**Our Case Number:** ABP-314964-22

**Re:** Proposed development of a Circular Economy Campus and an Integrated Waste Management Facility at the Hollywood Landfill  
Hollywood Great, Nag's Head, Naul, Co. Dublin, A41 YE92

Objection  
to an application by  
Integrated Materials Solutions Limited Partnership  
(Limited Partnership No: 1457)  
for an integrated waste management facility  
at Hollywood Great, Nag's Head, Co Dublin

from  
Patrick Boyle, B.E.  
Hollywood and District Conservation Group  
Hands Lane, Rush, Co. Dublin

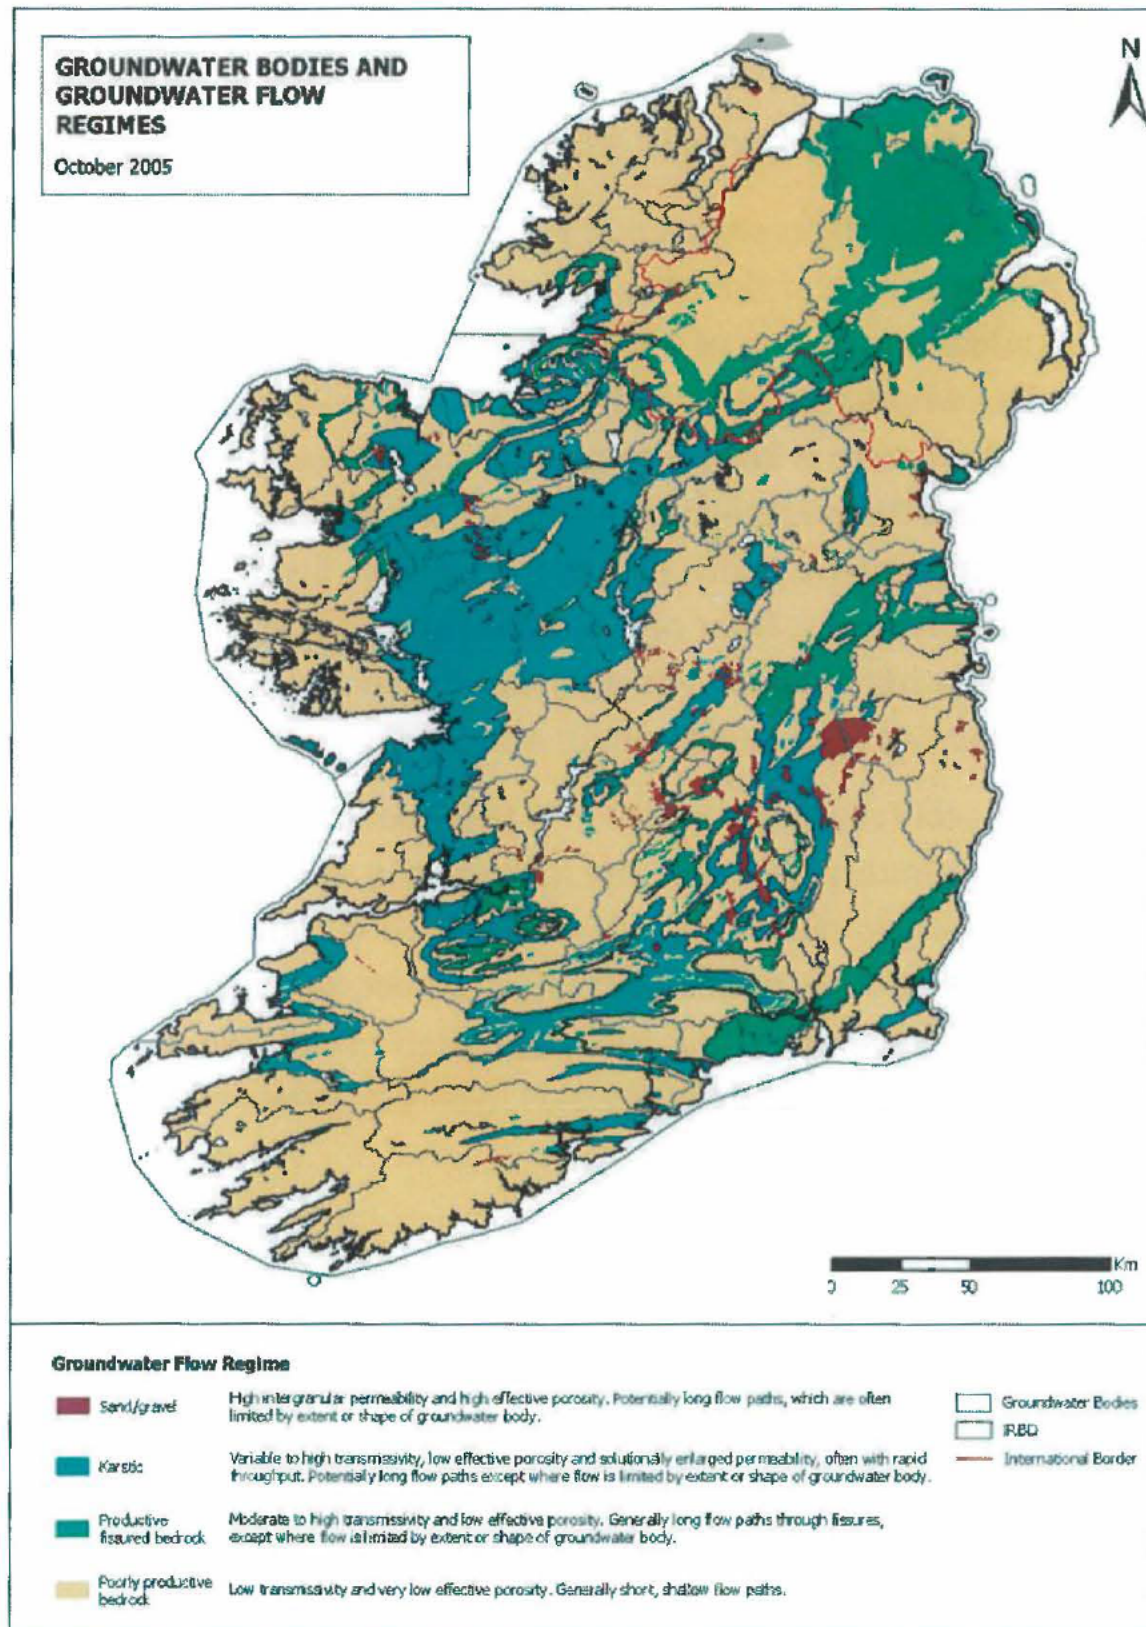
The map of Ireland (attached) is of “groundwater bodies and groundwater flow regimes” throughout Ireland.

The feature coloured green crossing Fingal from east to west between Rogerstown Estuary to the south and Skerries to the north and continuing over much of east County Meath, is categorized as “productive fissured bedrock”. On the GSI Response Matrix for Landfills (see attached) it has an Aquifer Category of Locally Important Moderately Productive Fissured Bedrock (Lm). It would be expected to sustain groundwater well yields of between 100m<sup>3</sup> and 400m<sup>3</sup> per day. (see attached “Aquifer Classification-GSI”)

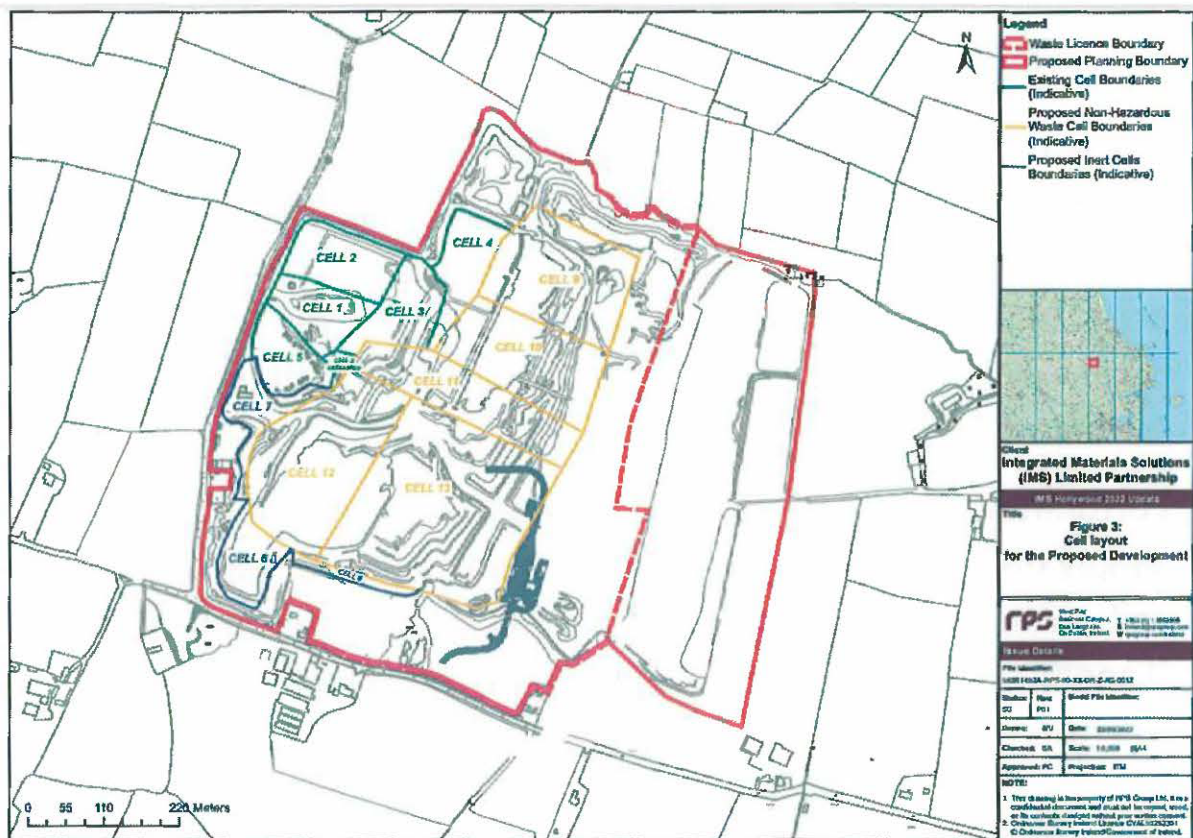
The proposed landfill is situated in a former rock quarry on the south-eastern slope of the Hill of Knockbrack, a Namurian shale rock feature, which sits on top of and is surrounded by the limestone aquifer. The whole feature is in the shape of a syncline. In geological terms the Namurian is known principally as the Walshestown Formation and the underlying limestone the Loughshinny Formation. The boundary between both passes through the proposed landfill, i.e. the Northern-most floor of the quarry sits on Namurian shale (W) whilst the southern section sits on the Loughshinny limestone (Lf) (see site maps and GSI geology map attached).

Note: An inaccuracy in the location of this boundary on the GSI map places the boundary too far to the north of the site. The site floor is thus principally Namurian, i.e., classed as a poor aquifer (See corrected site geology map attached). However, site specific investigations have found this rock to be highly fractured and may well be capable of groundwater yields locally in excess of 100m<sup>3</sup>/Day.

(see Regional GSI Geological map attached)

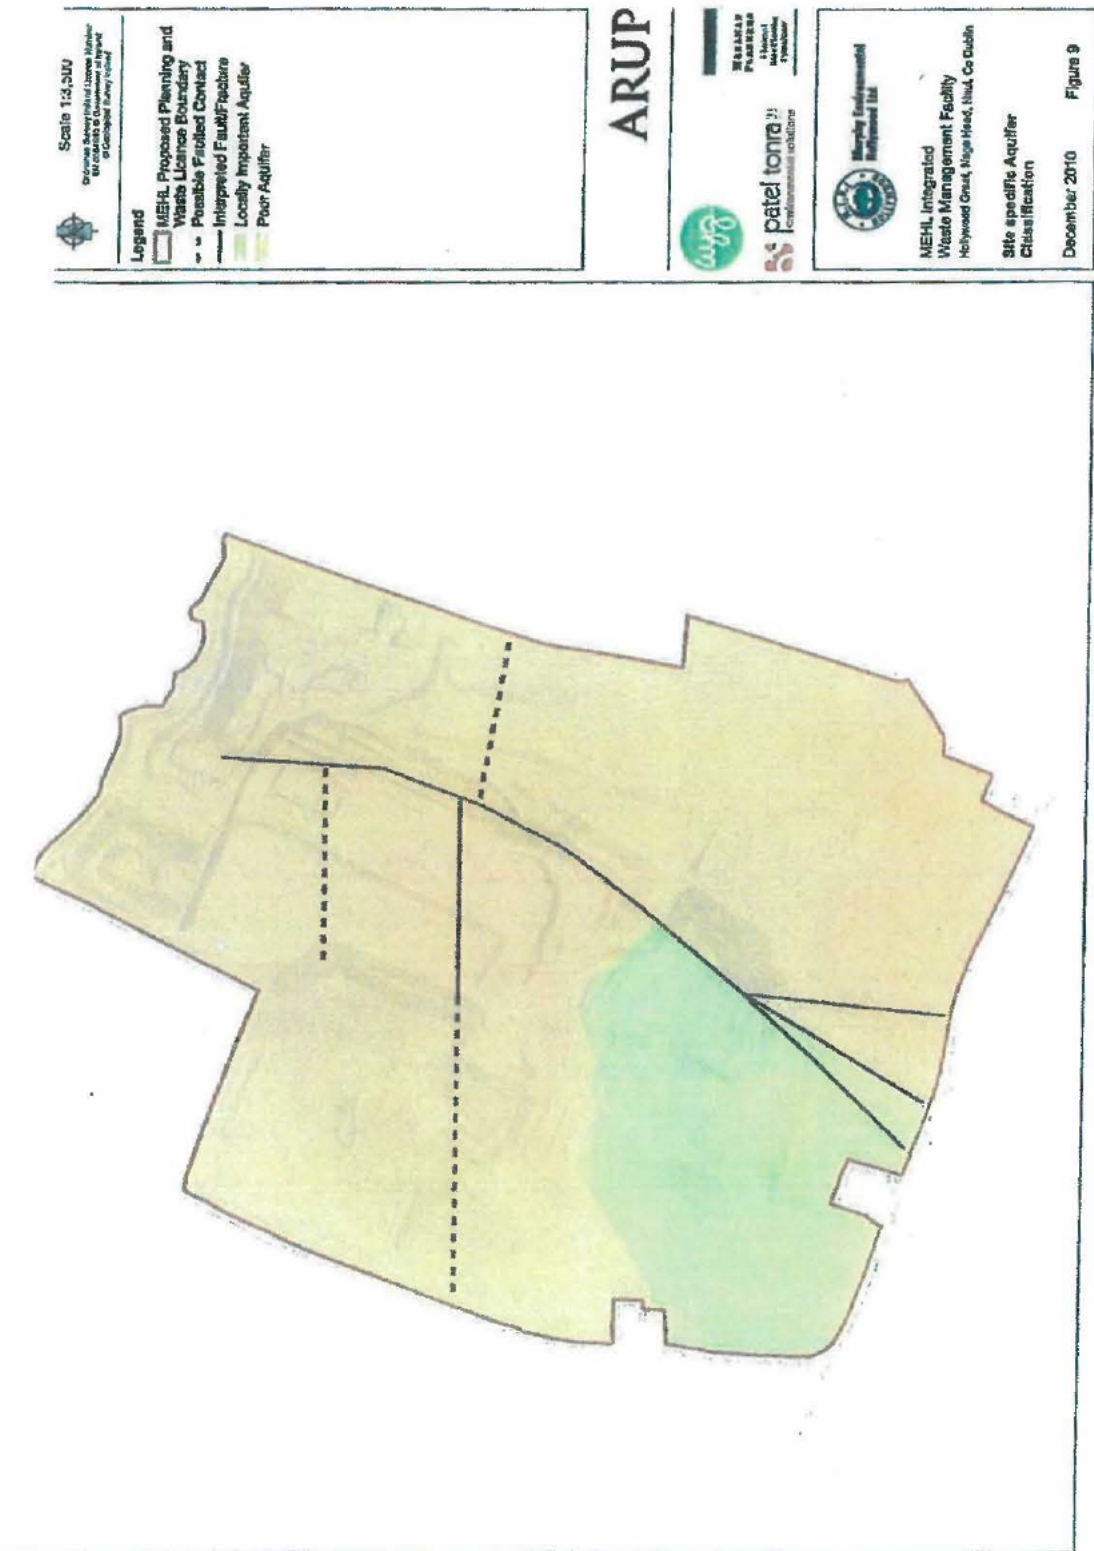
**In this he makes no allowance for the error in the GSI site geology i.e. that the waste cells are in fact underlain by the Namurian formation, where groundwater flow is proven to be eastwards, directly towards Hedgestown.**

- The Loughshinny Formation is shown incorrectly too far north on the site. (see Arup corrected site cross-section and aquifer plan attached)
- The GSI map also highlights in Green the Zone of Contribution of the Bog of Ring well field and the position of the southern water divide directly east from the proposed landfill site at Hedgestown.

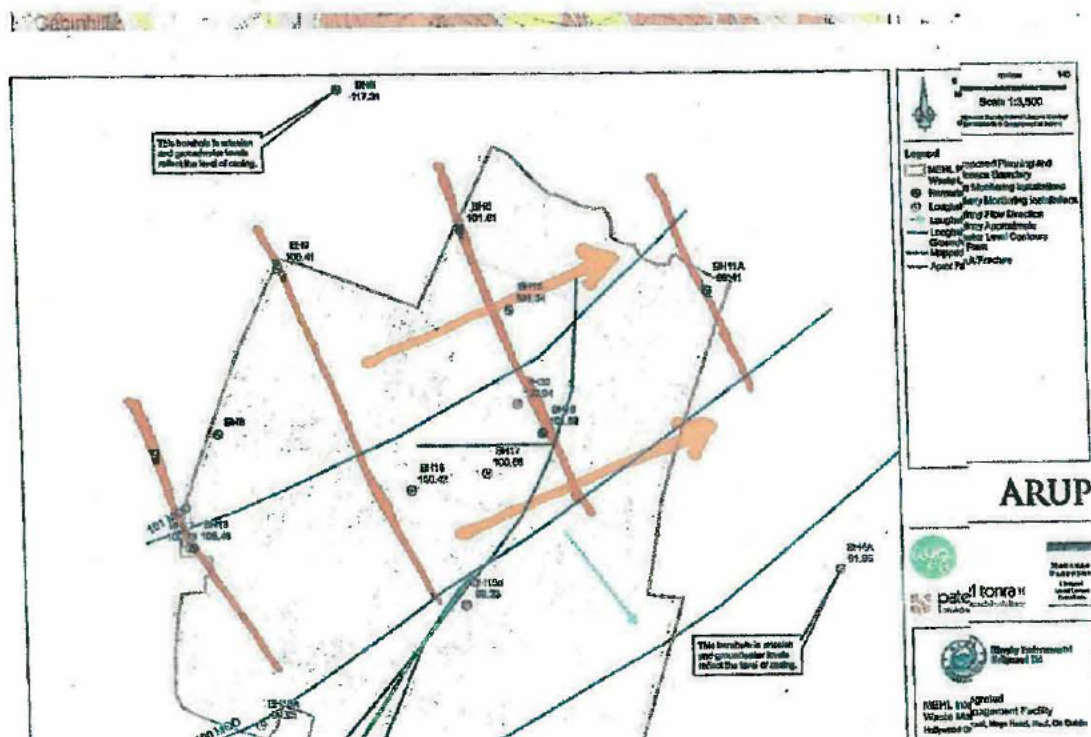
CDM Smith consultants conducted a site-specific study of the site for the applicant and produced groundwater level contours for the Loughshinny and Namurian formations. The resultant contours are shown attached.

They clearly demonstrate that the groundwater flow in the Loughshinny formation is to the southeast but the Namurian is likely to be eastwards, i.e. directly towards Hedgestown.

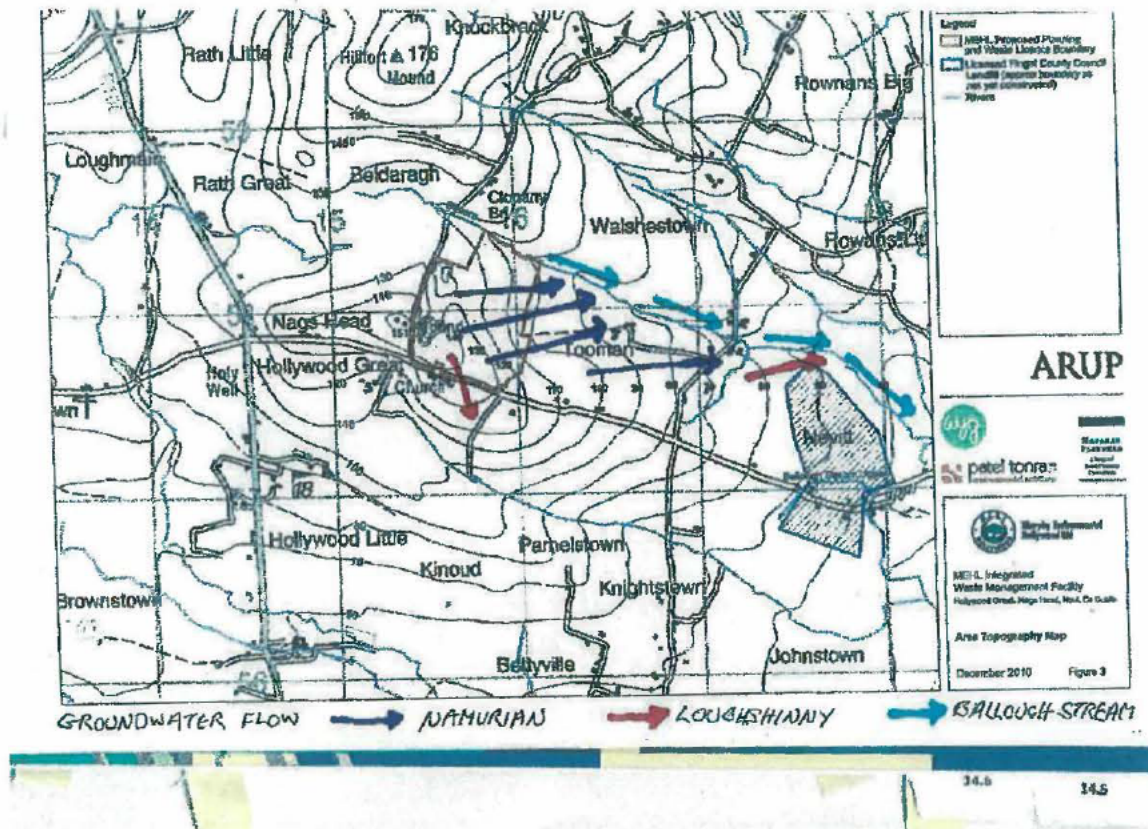
An examination of Namurian borehole data produced by Arup also demonstrates a slightly north easterly flow (see attached).

Note: In the absence of any borehole data to the east of the site being provided by the applicant, I have drawn provisional groundwater and surface water flow direction arrows eastwards based on topography. (see attached)
